# Addendum No. 2

**PROJECT:** Vivie Nelson Care Center Renovation, Alexandria, MN

**From:** Wold Architects and Engineers

**Subject:** Addendum No. 2 for Bidding Documents for the
**Vivie**
**Nelson Care Center Renovation**
**Alexandria, Minnesota**

# LIGHTING PLAN - AREA 'C'

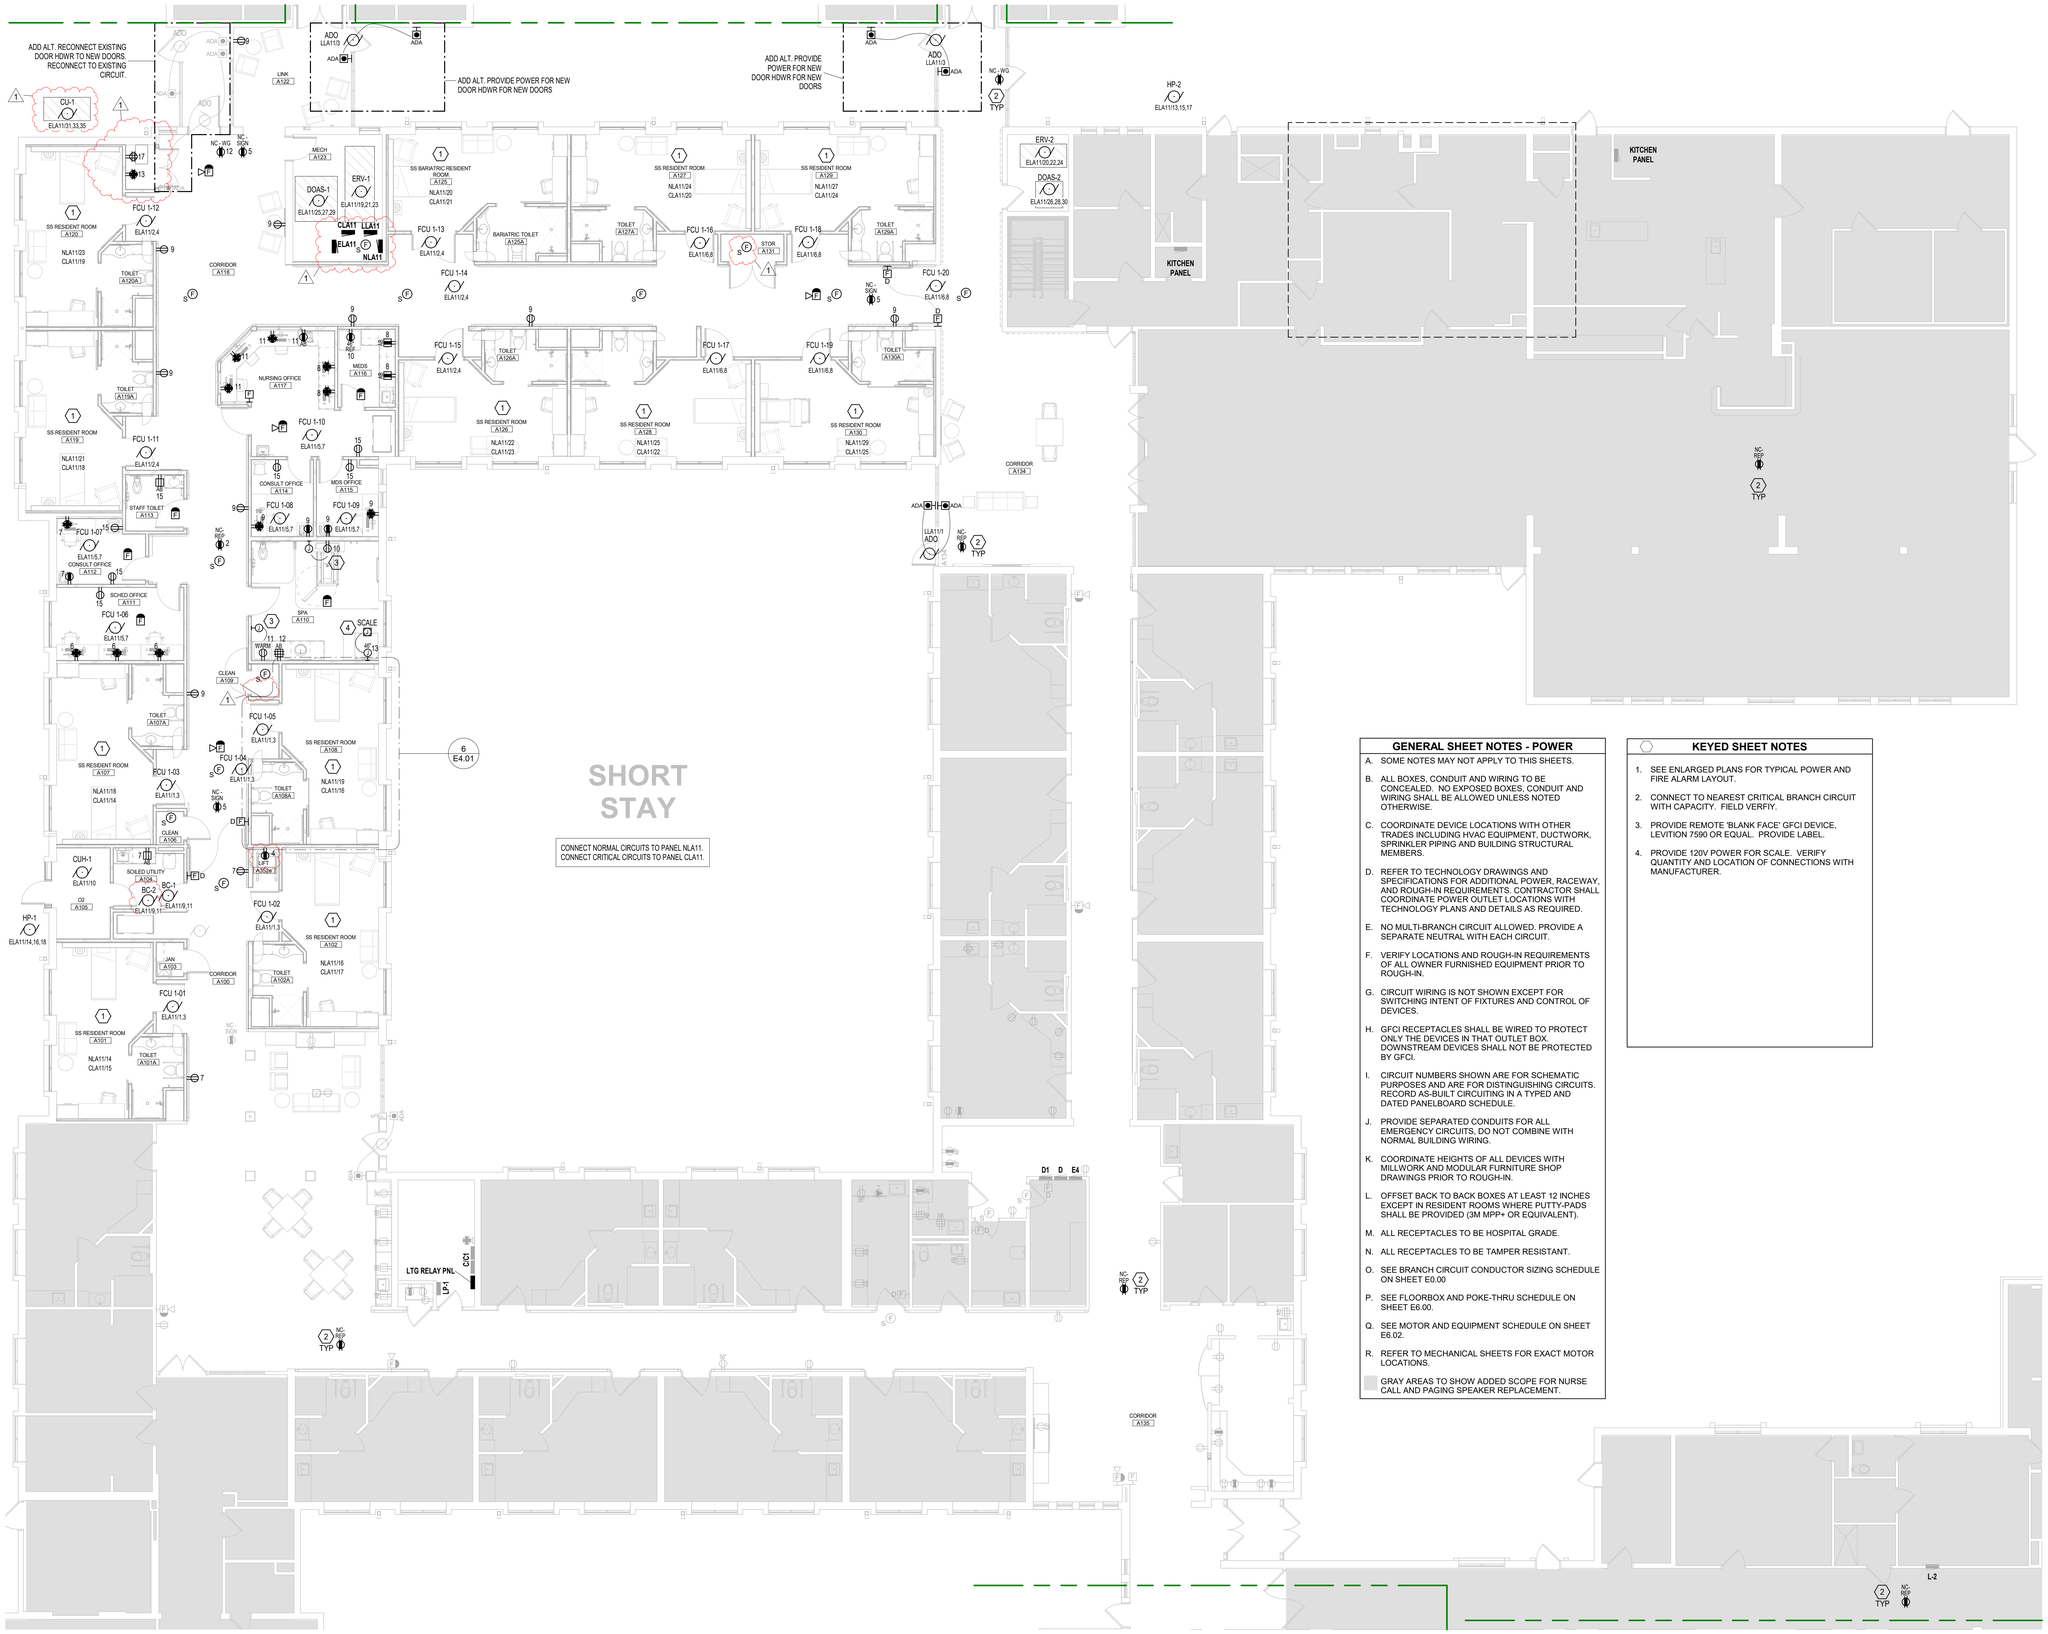
i. Additional lighting scope.
47. **DRAWING E2.001a - POWER & FA PLAN - AREA 'A'**
    A. **Reissued this addendum**
        i. Circuiting.
        ii. Additional scope.

# E2.001b

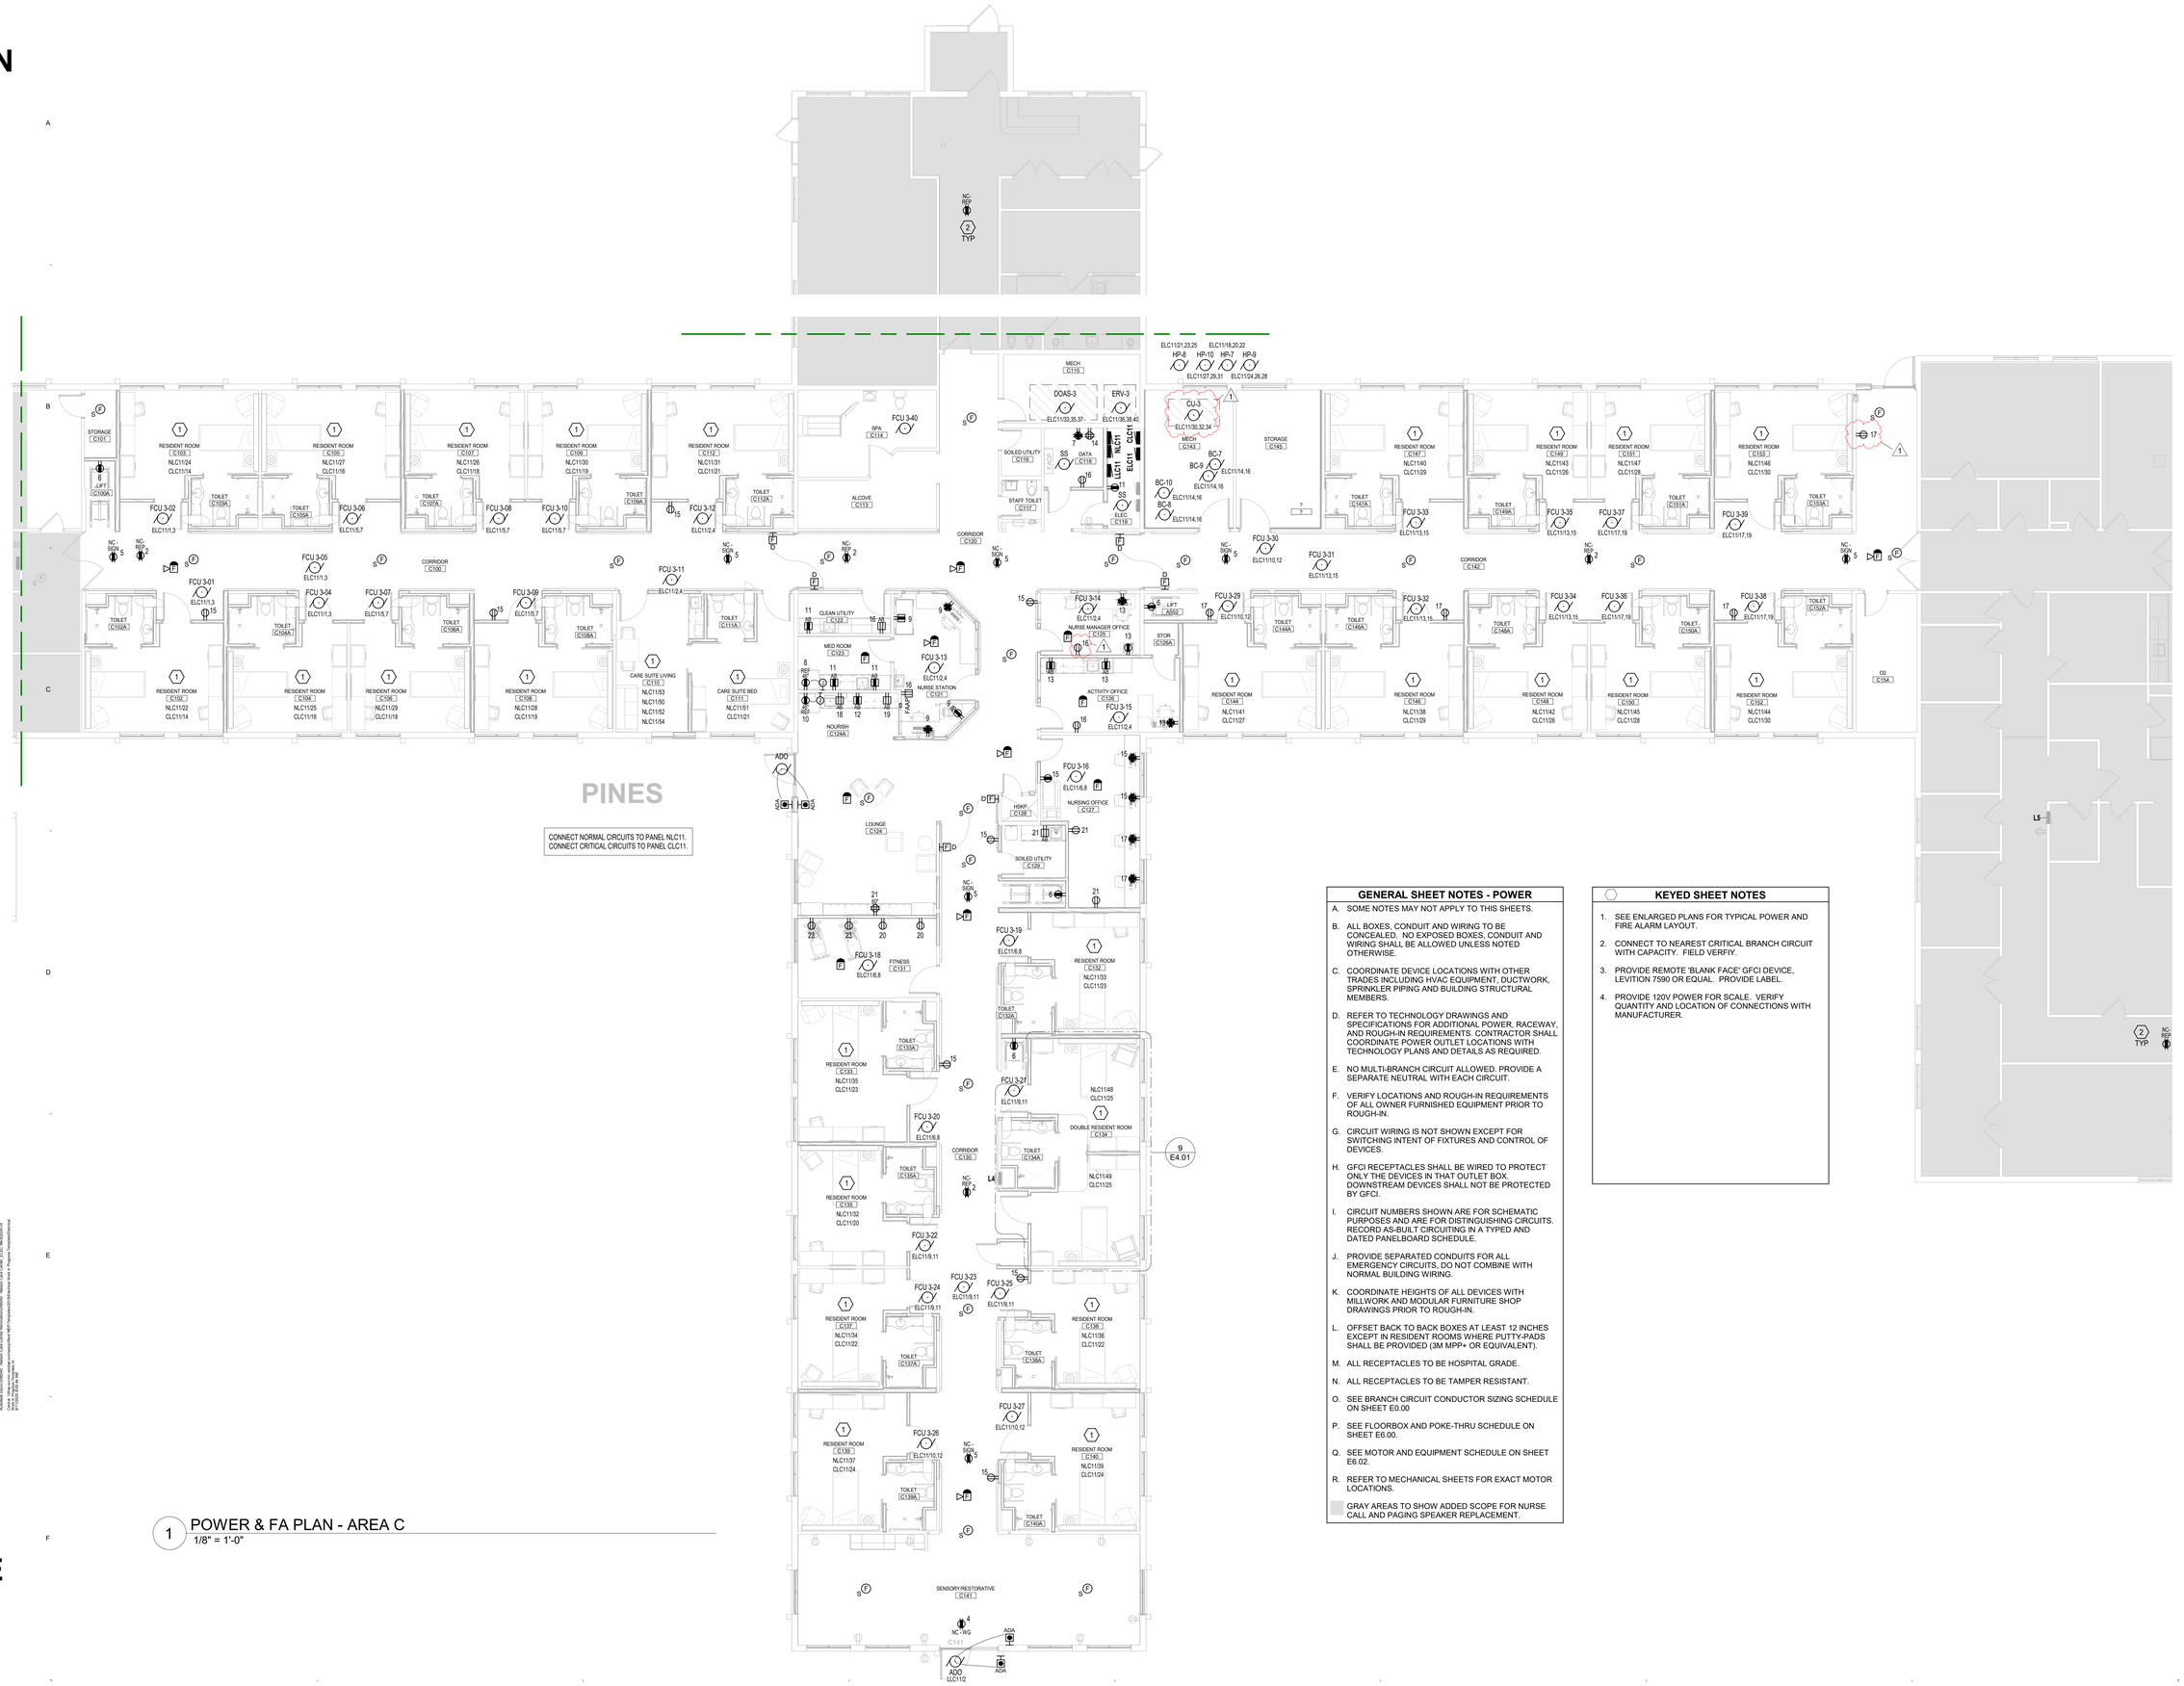
48. **DRAWING E2.001b - POWER & FA PLAN- AREA 'B'**
    A. **Reissued this addendum**
        i. Circuiting.
        ii. Additional scope.
49. **DRAWING E2.001c - POWER & FA PLAN- AREA 'C'**

# E2.001c

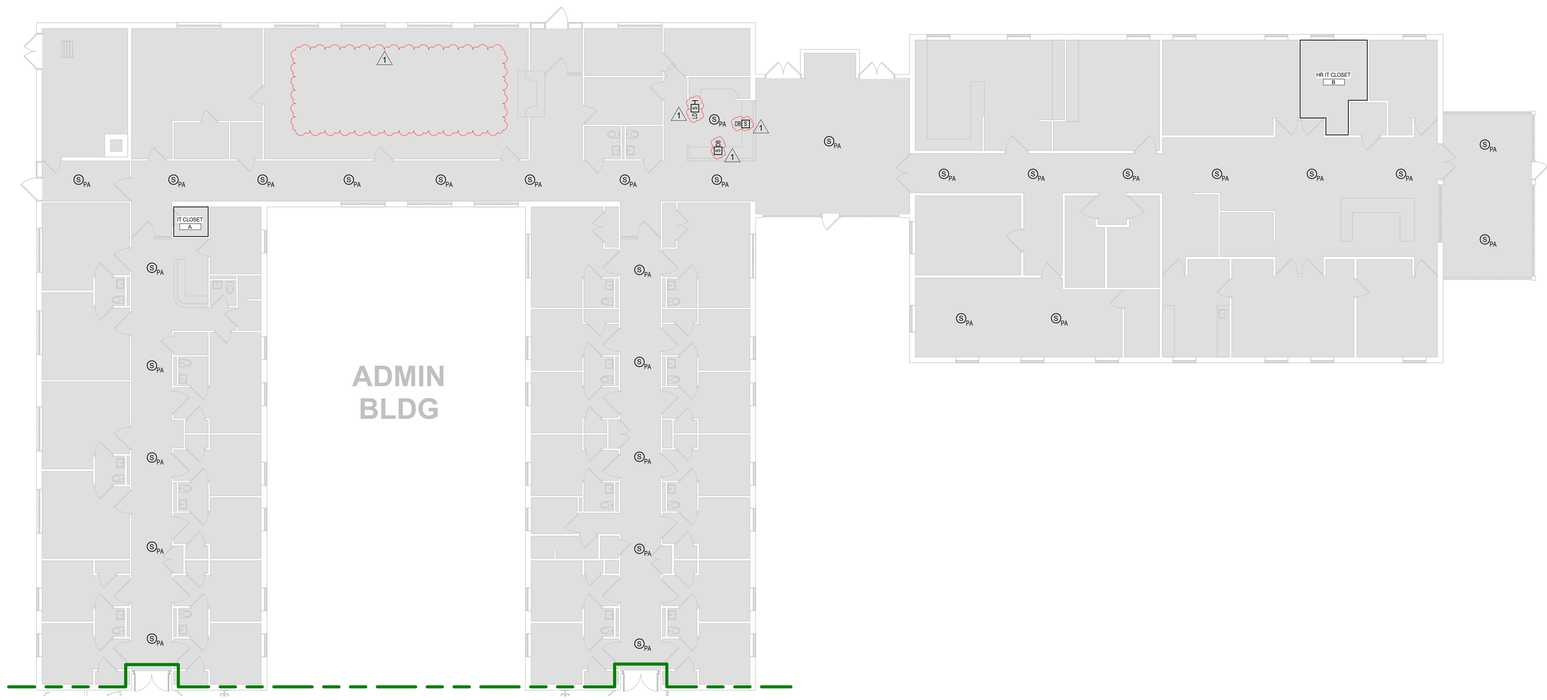
A. **Reissued this addendum**
        i. Circuiting.
        ii. Additional scope.
50. **DRAWING E3.001 – SYSTEMS PLAN – ADMIN BLDG**
    A. **Reissued this addendum**

# E3.001

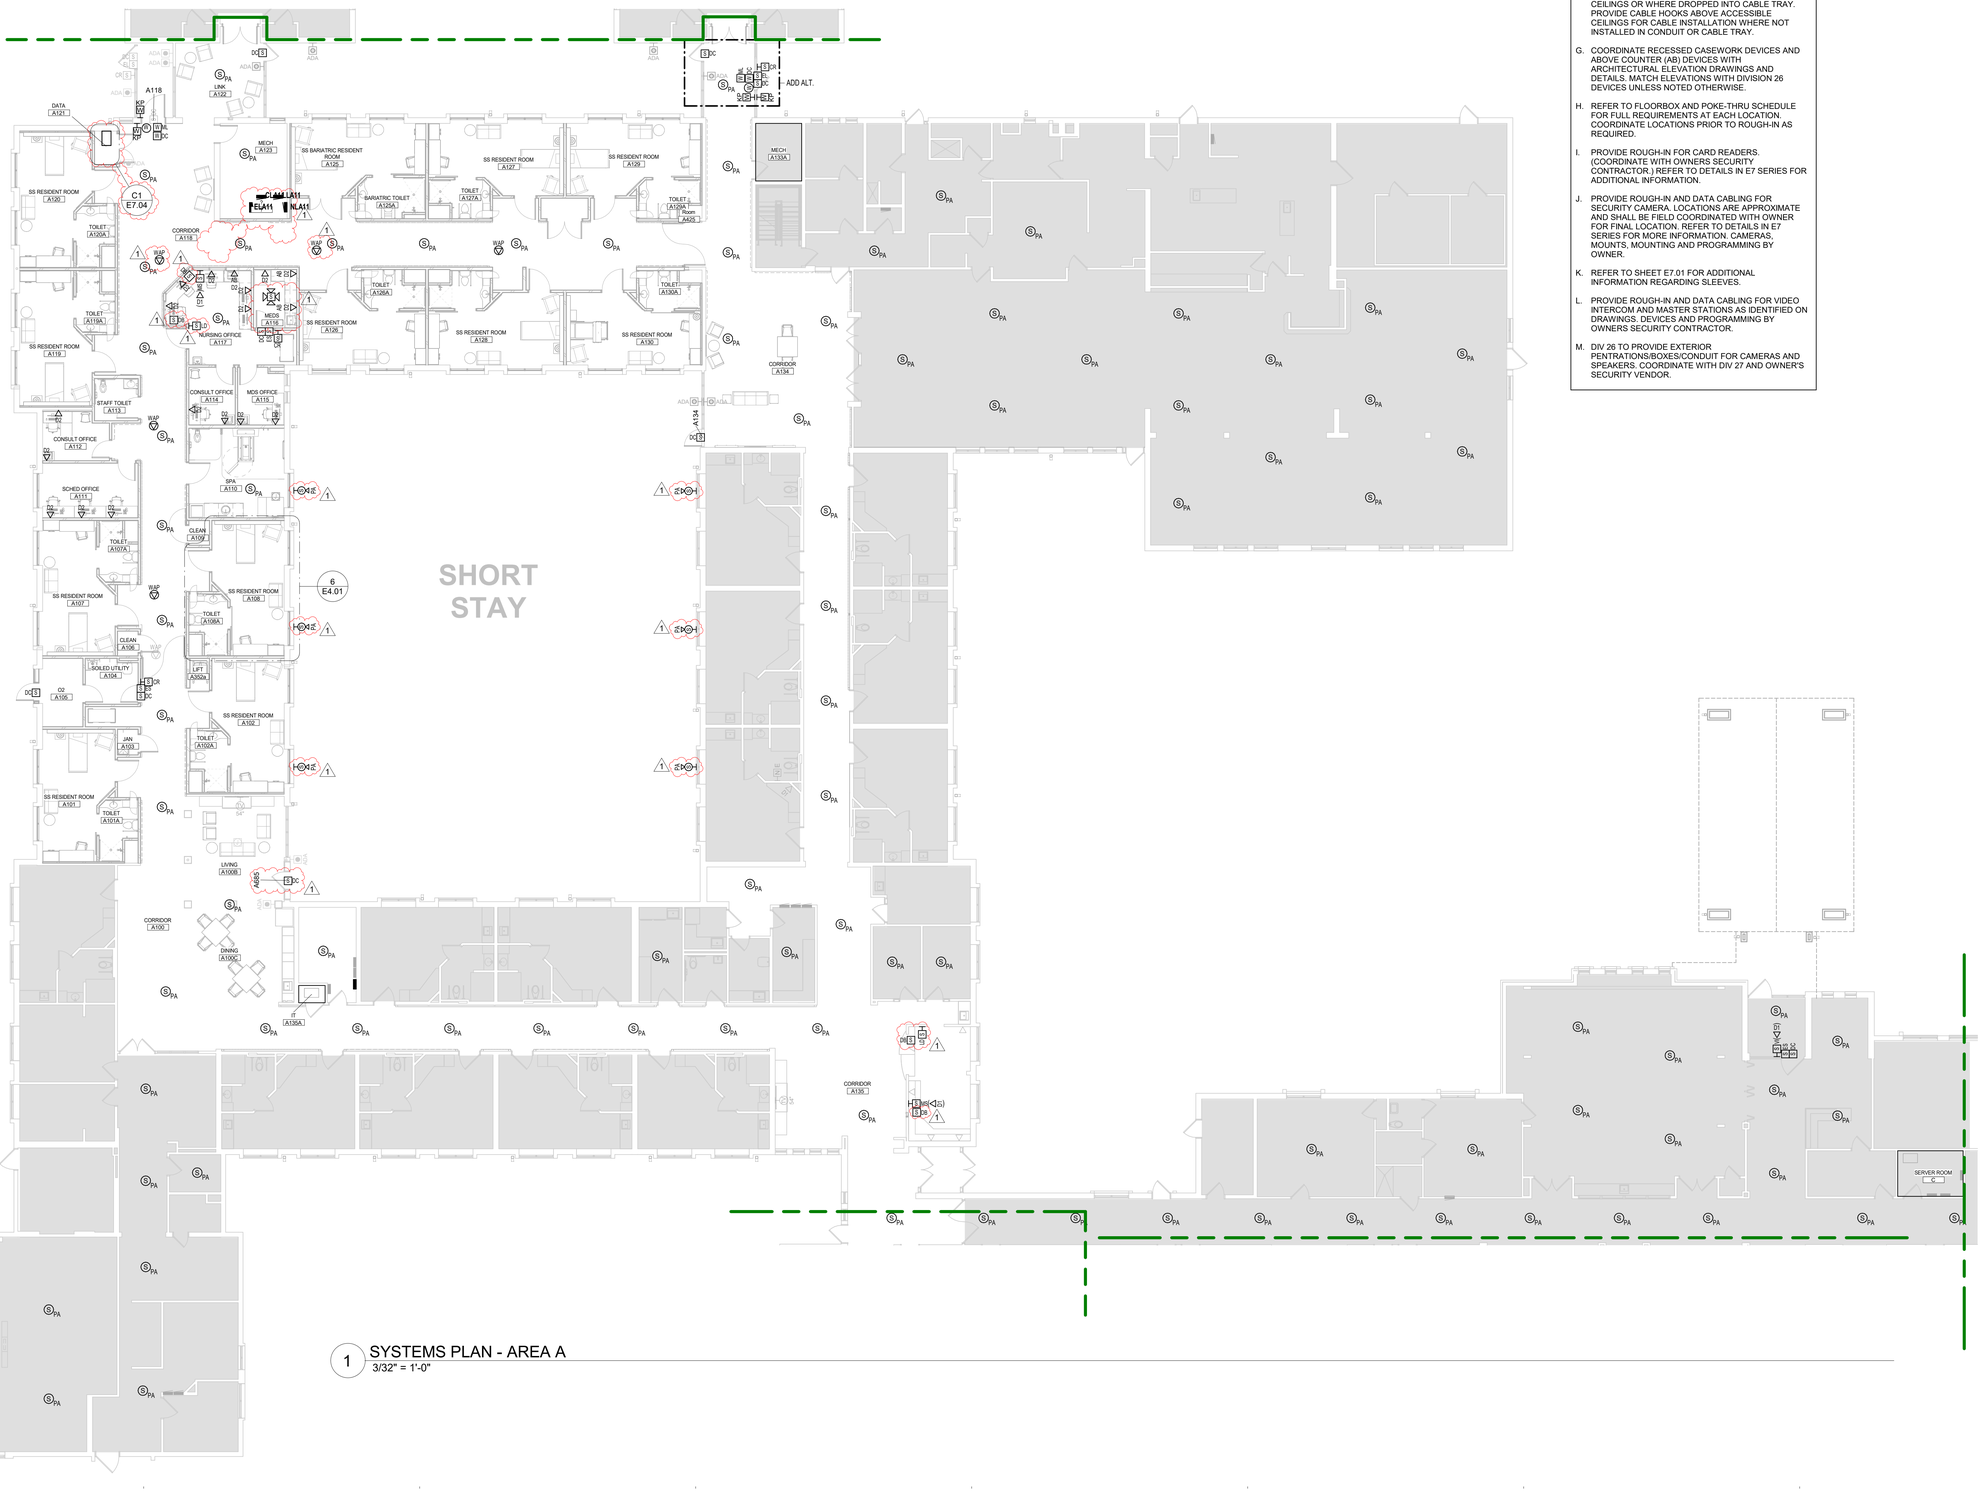
i. Revied scope as shown.
51. **DRAWING E3.001a – SYSTEMS PLAN – AREA 'A'**
    A. **Reissued this addendum**
